Product/Process Change Notice - PCN 14_0020 Rev. C

PCN Title: Conversion of 4x4mm body Size LFCSP Package Outlines from Punch to Sawn and Transfer of Assembly Site to Amkor Philippines.

Publication Date: 22-Dec-2014

Package Dimensions

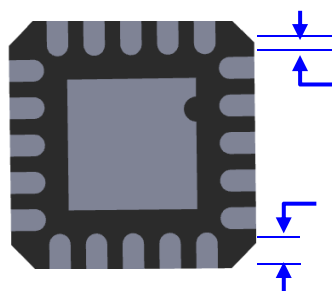
PUNCH

SAWN

Package Thickness Difference

Exposed Pad, Lead Length and Lead Width dimensions remains within tolerance.
